Address:	7107 Sycamore Ave., Takoma Park	Meeting Date:	5/24/2023	
<b>Resource:</b>	Contributing Resource Takoma Park Historic District	Report Date:	5/17/2023	
Applicant:	Sharon and Clark Bakewell Brian McCarthy, Architect	Public Notice:	5/10/2023	
<b>Review:</b>	Historic Area Work Permit	Tax Credit:	Partial	
Permit No.:	1029627	Staff:	Dan Bruechert	
Proposal:	Window Replacement and Areaway Construction, Utility Relocation and Stucco Repair

#### MONTGOMERY COUNTY HISTORIC PRESERVATION COMMISSION STAFF REPORT

The applicant proposes to excavate an areaway for basement access, install a new door and window well, relocate the utility meters, and repair sections of stucco.

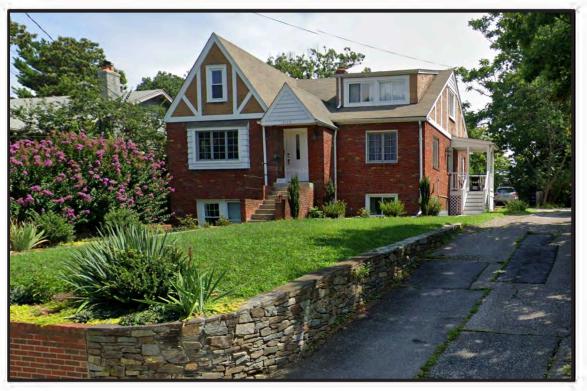
The applicant proposes to make alterations in two areas of the house. The first is the construction of a new areaway in the right front corner of the house. The second change is to alter a window at the left hear of the house to satisfy egress requirements with the installation of a new window well and larger window. Staff finds the overall impact of these proposed changes will not alter the character of the house or surrounding district and recommends the HPC approve the HAWP.

To the right of the front porch, the applicant proposes to create a new basement entrance. The proposed areaway will be L-shaped, constructed using parged CMU with a painted metal handrail. The stairs are 3' 4" (three feet, four inches) wide and the areaway extends from the right edge of the porch to the right edge of the house. To create the basement access, the applicant will remove an existing six-lite fixed window and install a half-lite door. A portion of the window opening will be repaired and covered with stucco to match the existing finish. The final change to accommodate the new areaway is relocating the existing gas meter to the side elevation.

Staff recommends the HPC **<u>approve</u>** the HAWP application.
